# **STANDARDS AND POLICIES MANUAL**

Technical Bulletin Three

**August 2024**

#### **AMENDMENTS TO “STANDARDS AND POLICIES MANUAL”**

COUNTY OF SANTA CLARA DEPARTMENT OF PLANNING AND DEVELOPMENT LAND DEVELOPMENT ENGINEERING	
<b>PRIVATE ROAD - 40' ROW</b> (URBAN)	<b>SD</b> <b>1A</b>

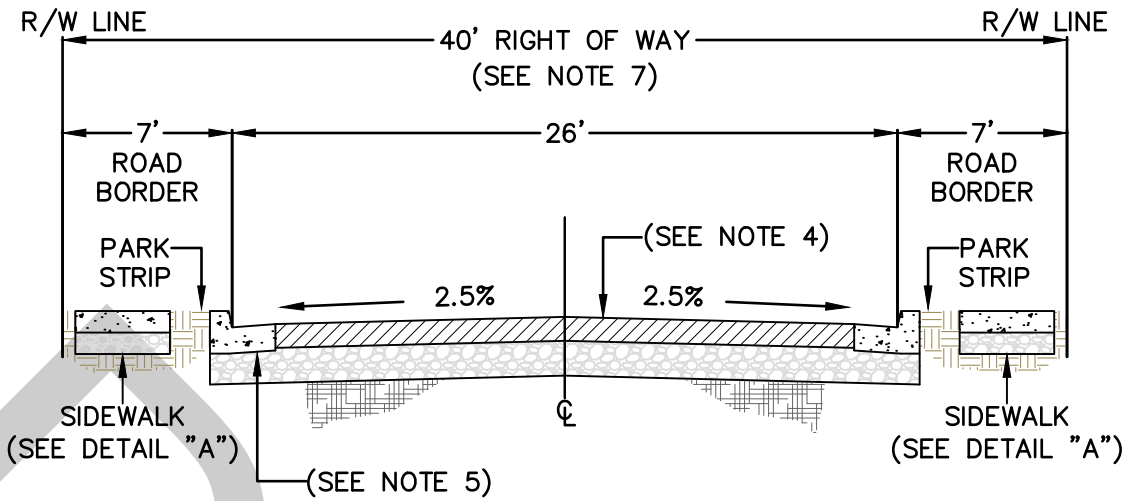
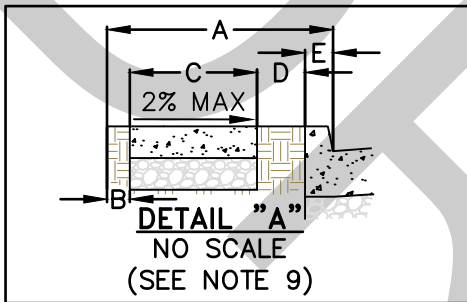
**PRIVATE ACCESS ROAD DETAILS:** The current SD1 detail in the Manual is intended for use in providing public ingress and egress over privately maintained roads outside the County-maintained right-of-way. An additional design detail (SD1A) has been added to allow for as narrow as a 40-foot right-of-way dedication, consistent with County Roads and Airports standards. The SD1A detail is intended for use in urban areas where lesser right-of-way widths may be appropriate, providing for a reduced 40-foot total right-of-way for new roads. The detail also includes a narrower road width of 26 feet within the urban areas when the road is intended only for residential access (and not to carry through traffic), i.e., no provision for roadside parking. See Attachment 1 for the new SD1A detail, which is generally consistent with County Roads and Airports Standard Detail A9.
